City of Santa Fe, New Mexico

memo

2026-011886-HDRB. 521 Calle Corvo. Downtown and Eastside Historic District. Contributing. Rajah Bose, agent for Louis Pepper and Ruth Williamson, owners, request approval for a 348 sq. ft. addition to a height of 14'-05" where the maximum allowable height is 16'-4", window, door, and portal replacement. Exceptions are requested to 14-4.6(G)(4)(I)(a) historic windows shall be repaired or restored wherever possible, 14-4.6(G)(4)(I)(c) no new opening shall be made where one presently does not exist unless historic documentation supports its prior existence, and 14-4.6(G)(4)(II)(a) architectural features, finishes, and details other than doors and windows, shall be repaired rather than replaced.

Figure 5. Existing and Proposed South Elevation.

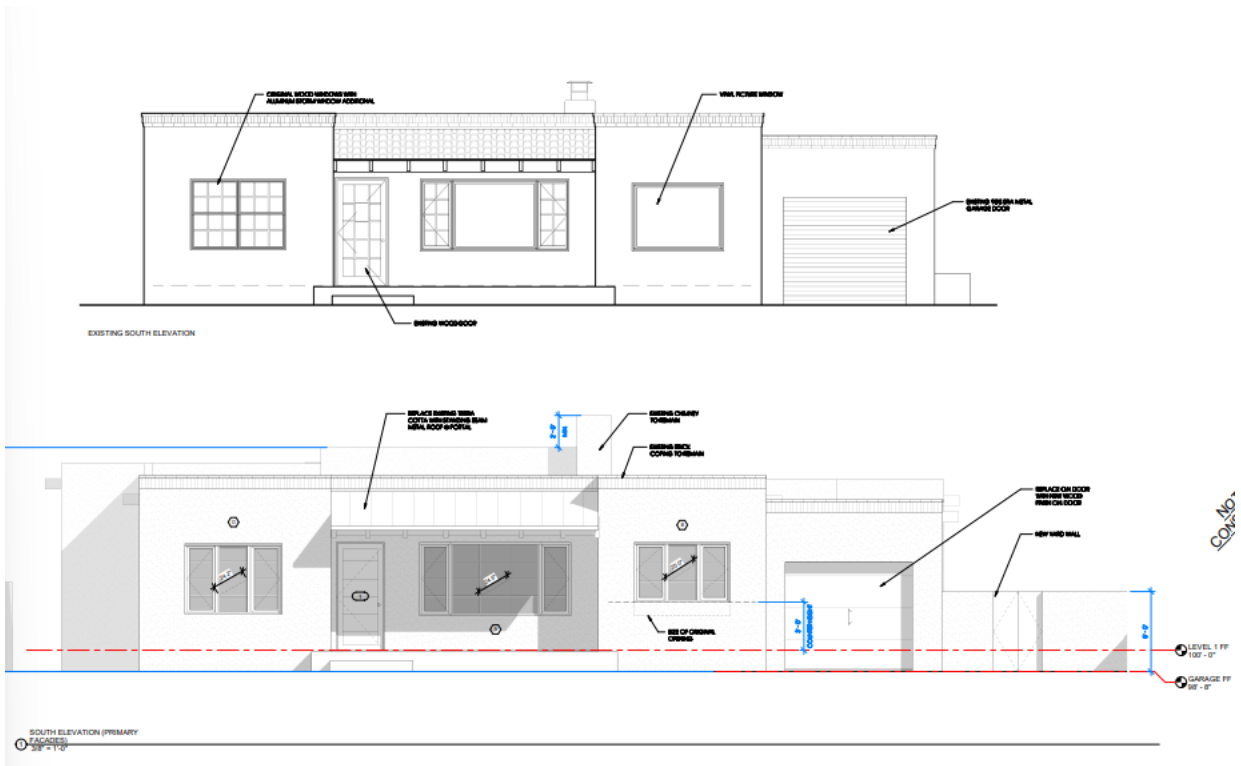
Exception to 14-4.6(G)(4)(I)(a) historic windows shall be repaired or restored wherever possible: The applicant requests an exception to replace historic windows on the south primary façade.

Staff Response: Staff finds that this criterion is not met. The proposed wholesale window replacement with divided-lite windows on the south primary façade change the historic conception and give a false sense of history on this streetscape where many of the homes on Calle Corvo were constructed with picture windows.

Staff Response: Staff finds that this criterion is not met. The applicant poses a good argument, however given the current code citation which states, “historic windows shall be repaired or restored wherever possible” on the primary facades the applicant has not provided sufficient information to justify the removal of historic windows and more information is needed for the Board to determine the current condition of these historic doors and windows.

Staff Response: Staff finds that this criterion is not met. The applicant proposes another relative argument, however the applicant has not provided the Board a full range of design options to consider, rather they have

chosen to present a whole-sale window replacement with limited information on the reparability of the historic windows. Additional information is needed for the Board to make a decisive decision for the proposed window replacement.

Exception to 14-4.6(G)(4)(I)(a) no opening shall be widened or narrowed: The applicant requests an exception to narrow a historic window opening from 4' high by 4' wide to 3' high by 4' wide.

Staff Response: Staff finds that this criterion is not met. Given the Board's recent status review and primary façade designation for the subject property, the current request to narrow the picture window would adversely impact the primary façade and the streetscape and additional information is needed to assess the current condition of the historic window opening.

Staff Response: Staff finds that this criterion is not met. No hardship has been found to change the current dimensions of the picture window on the primary façade.

Staff Response: Staff finds that this criterion is not met. The applicant has not provided the Board a full range of design options to consider, additional information is needed for the Board to make a decisive decision for the proposed narrowing of the historic window opening.

Exception to 14-4.6(G)(4)(II)(a) architectural features, finishes, and details other than doors and windows, shall be repaired rather than replaced : The applicant requests an exception to replace the terra-cotta portal roof tile with a metal standing seem roof.

Staff Response: Staff finds that this criterion is not met. The defining character of the Calle Corvo streetscape is what needs to be taken into consideration and several properties have portals with the terra cotta tiling as roofing material. There are no properties along this streetscape that have metal standing seem portal roofs publicly visible on Calle Corvo.

Staff Response: Staff finds that this criterion is not met. No hardship has been found to change the roofing material from terra cotta tile to a metal standing seem roof.

Staff Response: Staff finds that this criterion is not met. The applicant has not provided a full range of roof options for the current terra cotta tile portal. A metal standing-seem roof option seems to be an extreme change

to the historic portal that currently exists. Additional information may need to be requested to clearly identify the best options for re-roofing the portal with the proper material.
